Village of Lincolnwood Plan Commission

SUBJECT: Plan Commission Workshop – Review Revised Purple Hotel Concept Plans

Community Development Department Review

Project: 4500 West Touhy
Purple Hotel Property
Conceptual Plan Landscape Review
Lincolnwood, Illinois
Land Design Collaborative, Inc.

Conceptual
 Landscape Plan

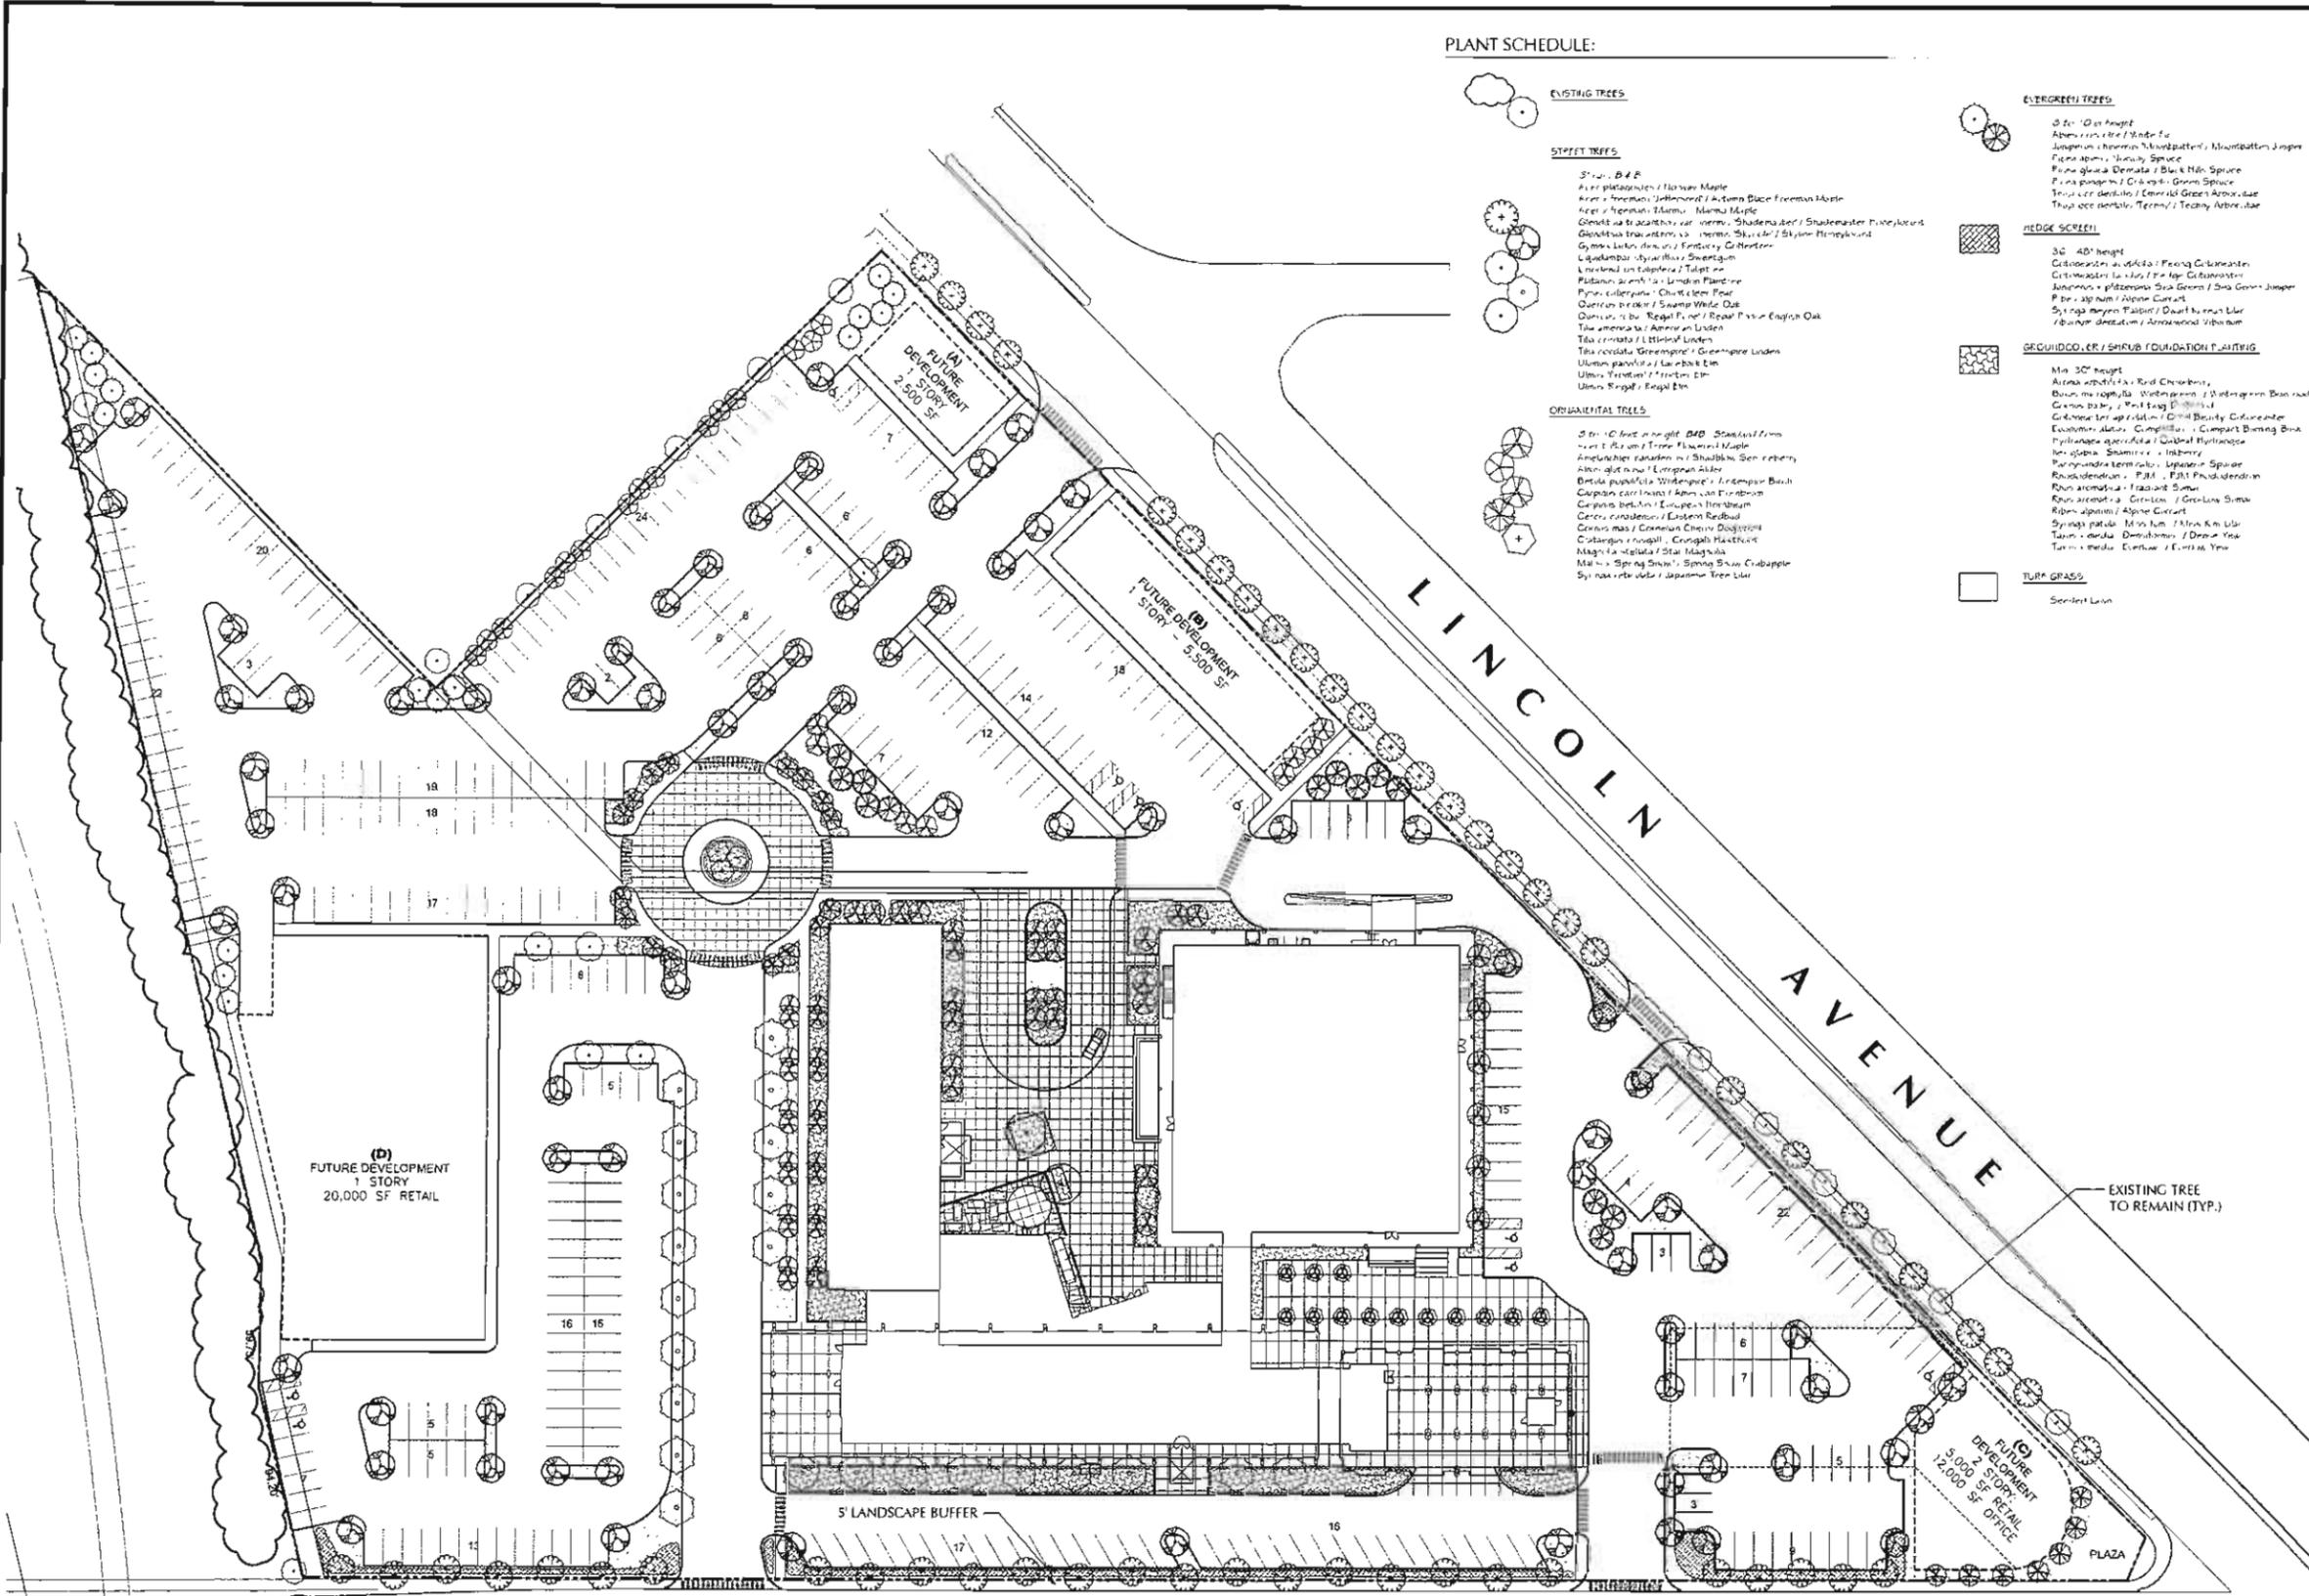
- (4) Shrubs shall be used whenever possible: there appear to areas along the buildings, in landscape islands and parking lot edges needing softening and screening requiring shrubs. These should be shown in a more detailed submittal.
- (5) Plants along long expanses of building walls: There are areas of the buildings (particularly #2) that should have more detail provided for shrubs and other plantings shown.

- (1) Perimeter Screening Required: The existing parking lot should be landscape screened along Touhy and Lincoln Avenues including a continuous wall (5 feet wide) or shrubs (8 feet wide). The planting shown does not indicate space for shrubs or a wall for screening the parking along Lincoln Avenue at the midpoint drive area (basically the area shown in the photo).

- (2) Interior Landscape Requirements: These requirements should be applied. Particular attention should be paid to planting areas after 20 parking spaces (north end parking aisle and south east along Lincoln Avenue).

- Provisions for adequate space (3 feet width) for required hedge plantings meeting the landscape Ordinance for continuous parking lot screening along Lincoln Avenue does not appear to be provided.

- Spacing of street parkway shade trees must be 25 feet apart.
- Site and pedestrian lighting is essential to provide safe pedestrian routes through parking and to illuminate dark areas adjacent to the building.

DRAWING NO.
L-03

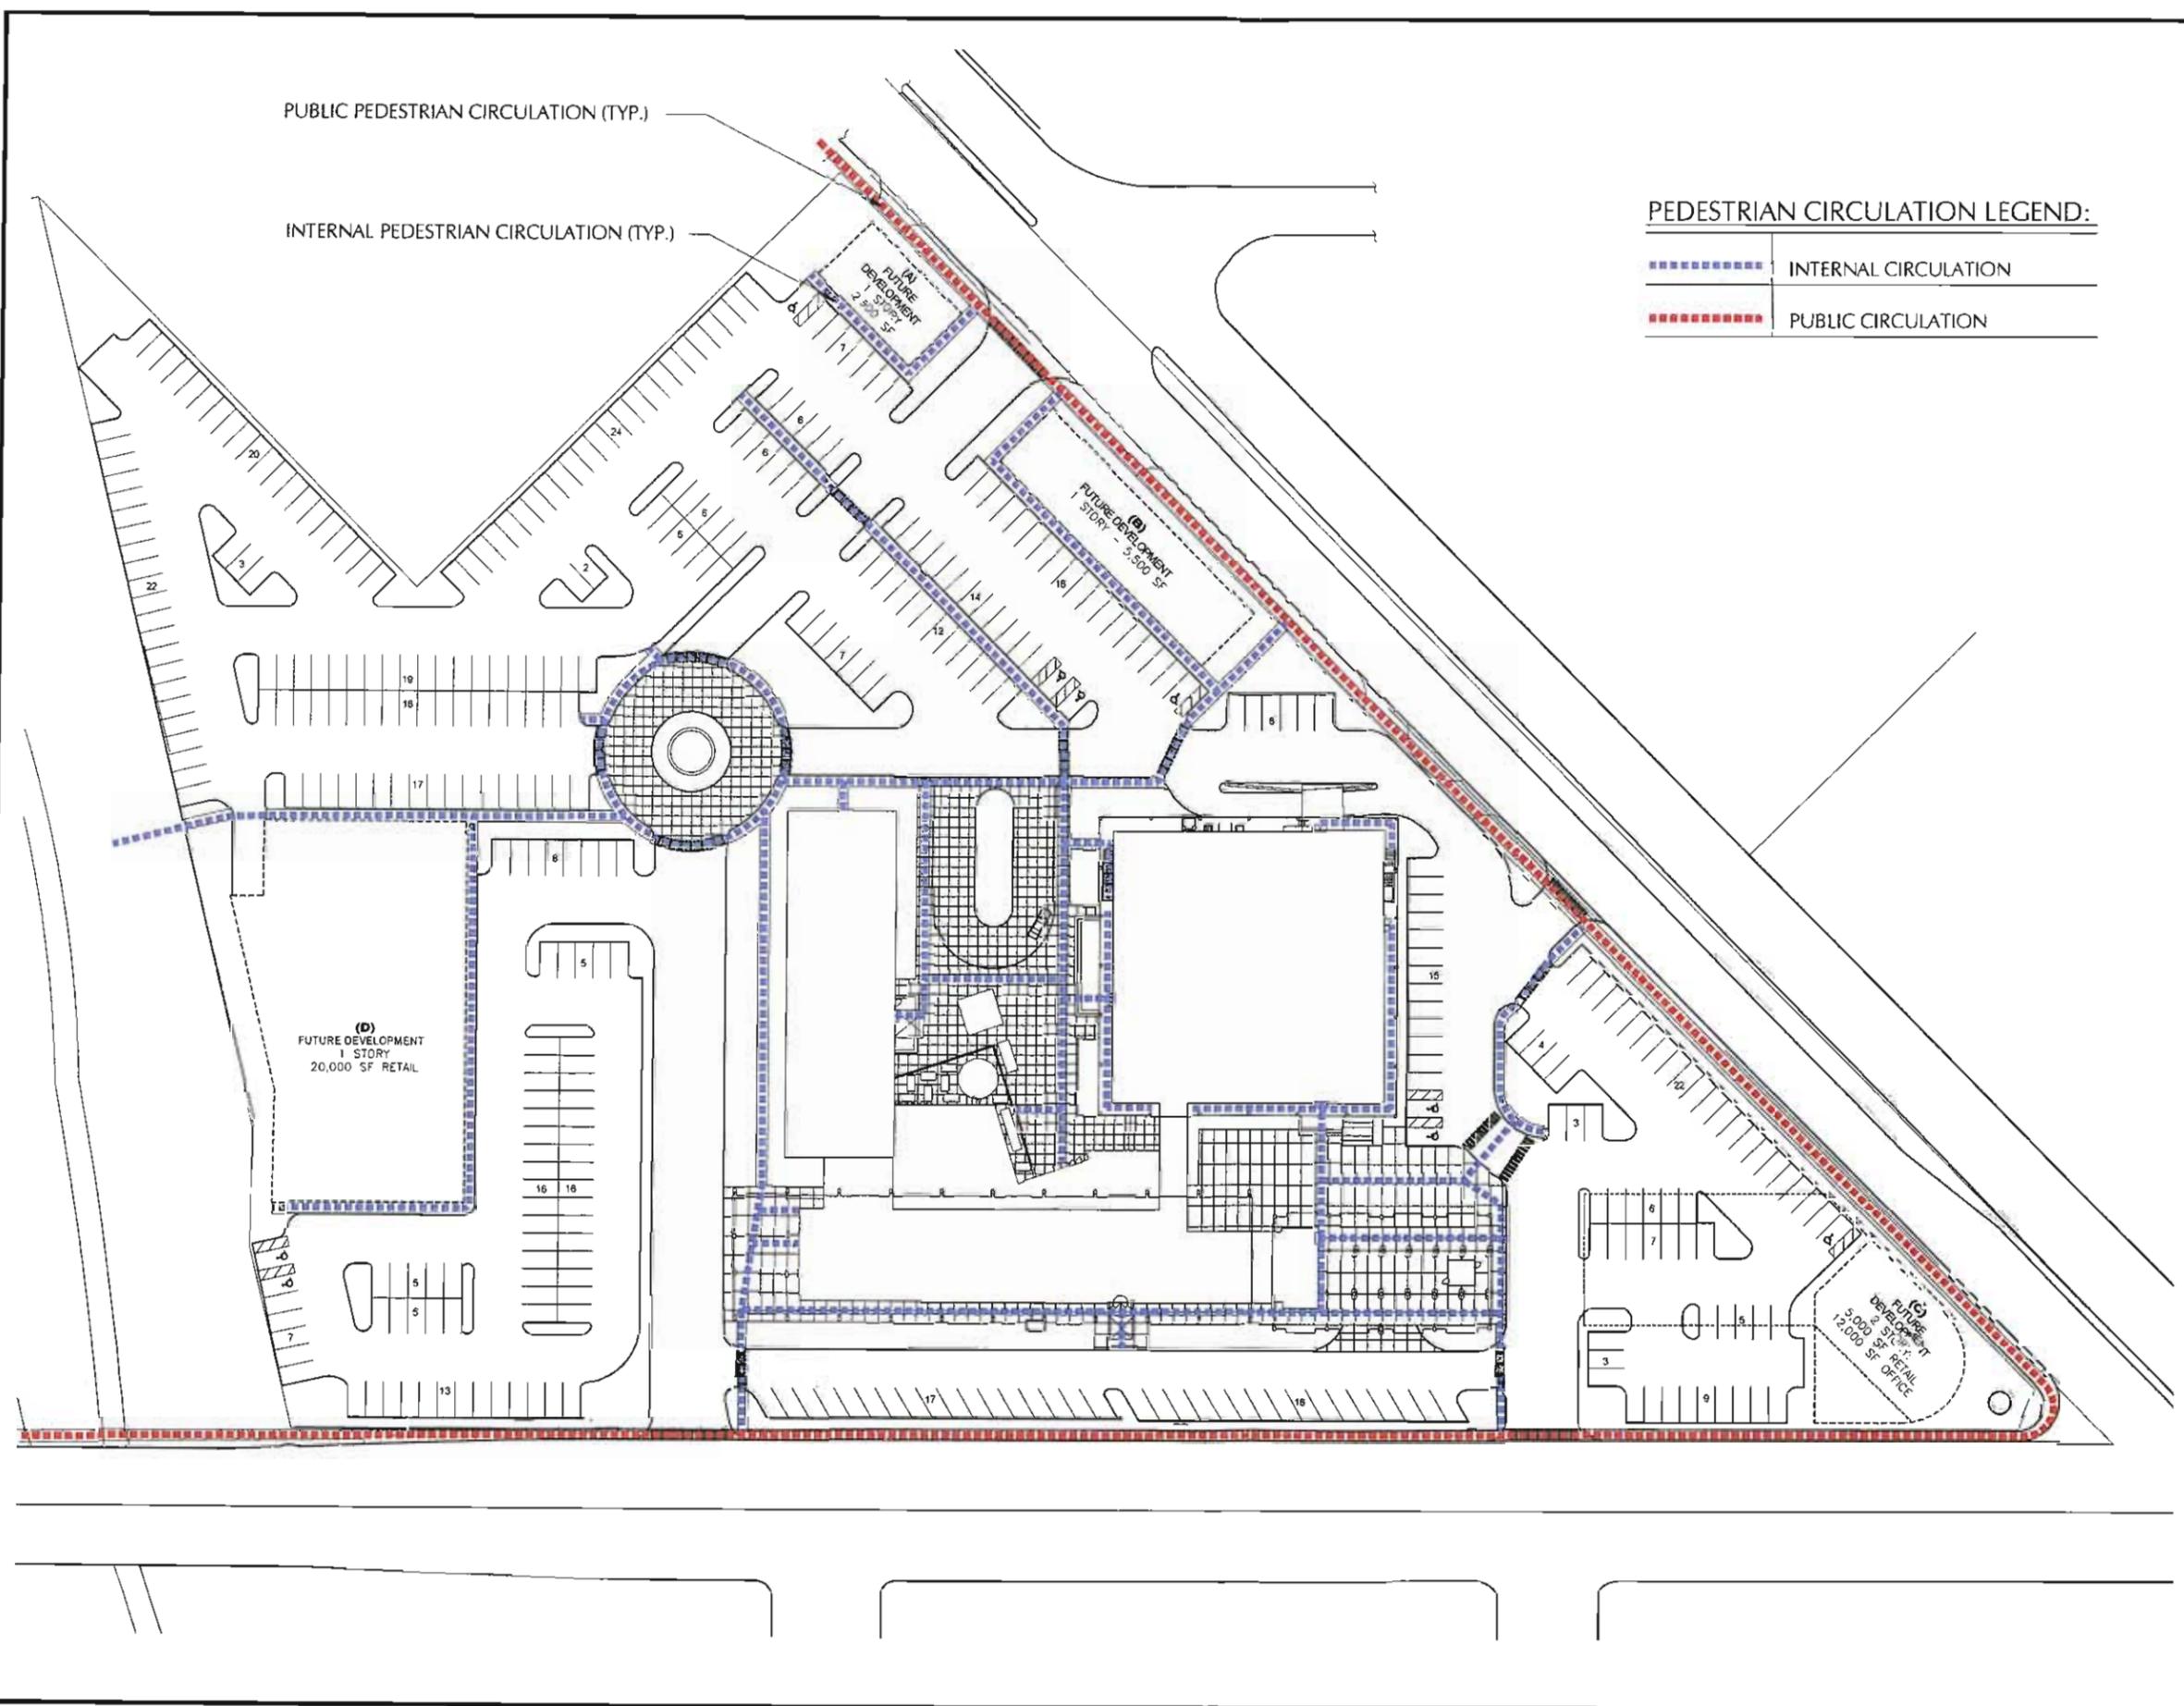
- The walk along the south side of the building should have additional access from the roadway such as a carriage walk, for pedestrians to safely step out of the roadway to the sidewalk. A mid-way connection from road to building walk in the west portion would also be useful.

- The placement of walks should be considered along the side of the main entry drive from Lincoln Avenue to the round-about.
- Consider an east-west walk along the south façade of the west Future Development connecting to the south face of the hotel. Also connecting to the proposed parking in the ComEd right of way.

- Consider an east-west walk at the southeast corner of the hotel across the drive to the southeast Future Development parking area.
- Pedestrian Linkages from outer parking lots to Buildings are inadequate. Additional walkways should be added for pedestrians walking between parking and building entries in the northwest lot and as described above.

- Walkways along the north side of Building 2 are not shown for pedestrians to walk past the dumpster area screen wall.

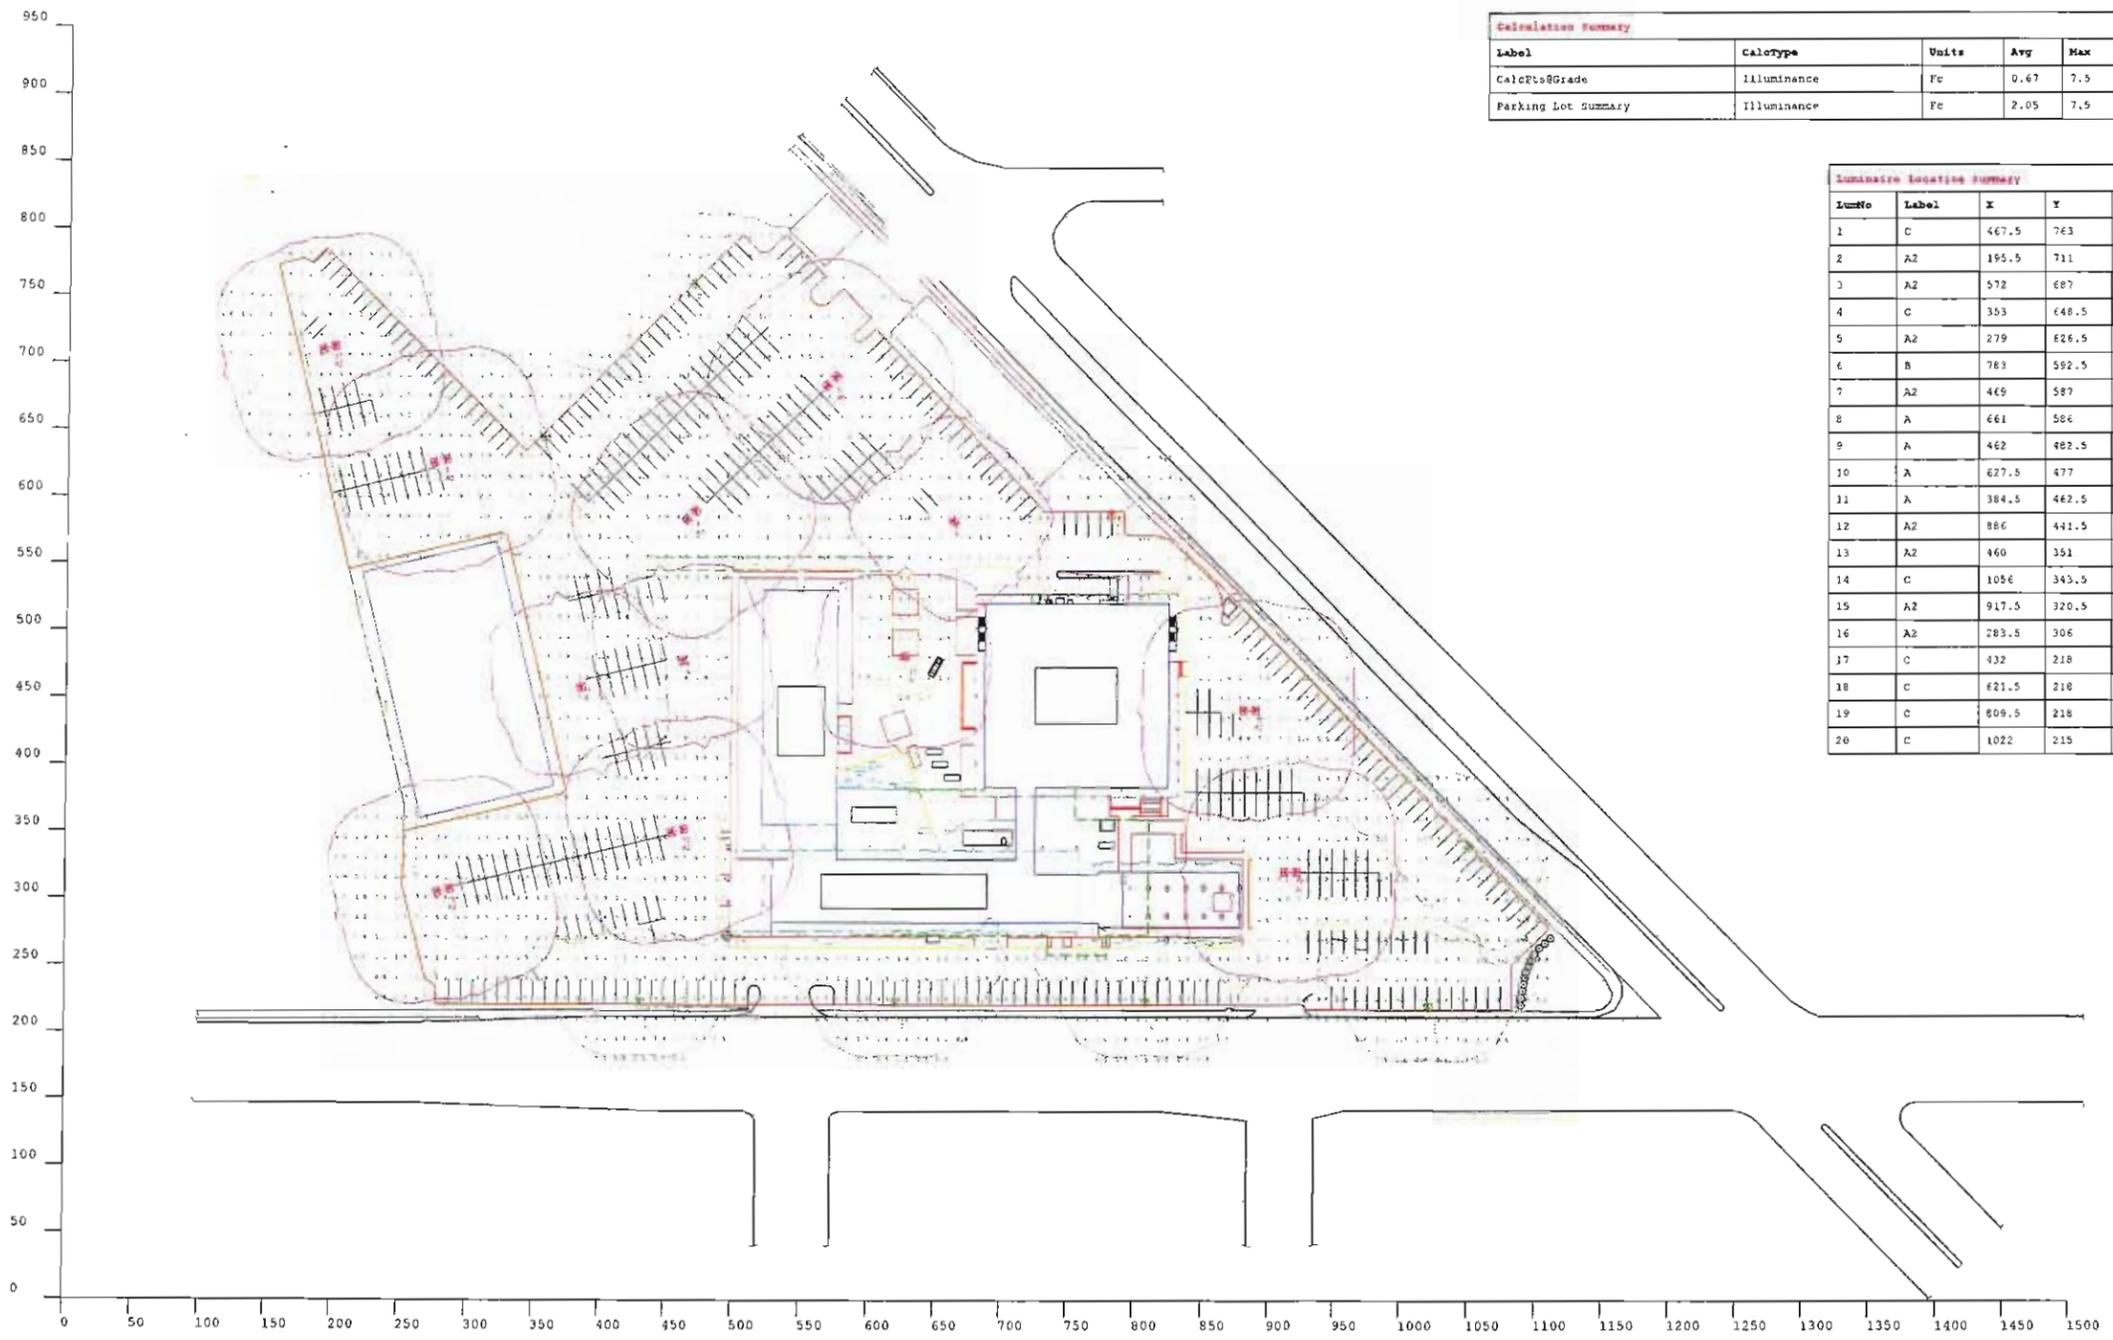
- ❖ The lighting plan indicates that 1 foot candle at property lines is exceeded in several locations.
